FEDERAL COMMUNICATIONS COMMISSION
Equipment Authorization Division, Application Processing Branch
7435 Oakland Mills Road, Columbia, MD 21046
Telephone: (301) 725-1585, ext 230 Facsimile: (301) 344-2050

RADIAL BV P.O. Box 64 3870 CB Hoevelaken, The Netherlands Phone + 31 (0) 33 253 40 09 Fax + 31 (0) 33 253 45 12		No. of pages - 1 - of - 2 -
FAX MESSAGE		
Cy : Lucent Technologies Attn : mr. Wilbert Smorenburg Dept : WCND From : M. Teeuwissen	Fax no : 030-6097556 Date : 18.07.96 Copy: F. Vauthelin, Radiall S.A. Paris	
Subject / Reference : FCC requirement for MC-card series

Subject / Reference : FCC requirement for MC-card series

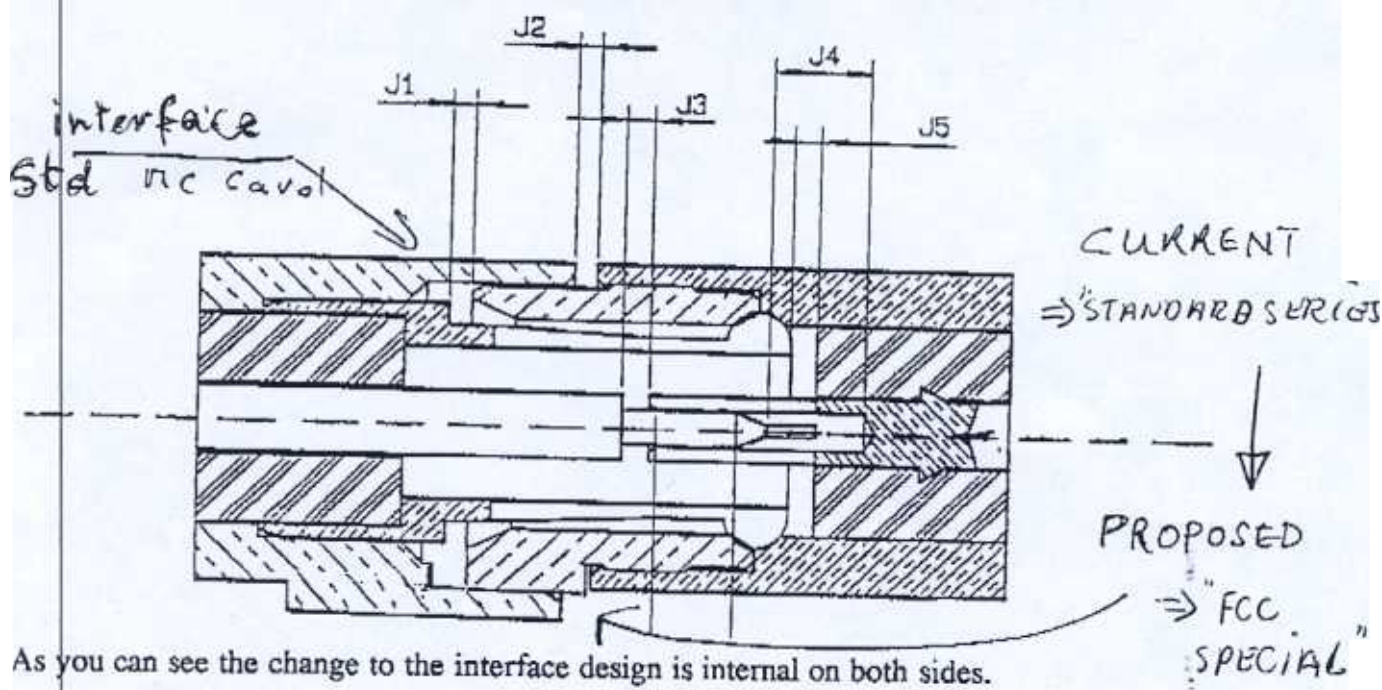
further to our conversation just now please find enclosed the explanatory sketch, which will make the difference between current and proposed situation clearer:

As you can see the change to the interface design is internal on both sides.

This is in response to your fax dated July 19, 1996. From the information provided, it appears that the proposed antenna connector does comply with Section 15.203.
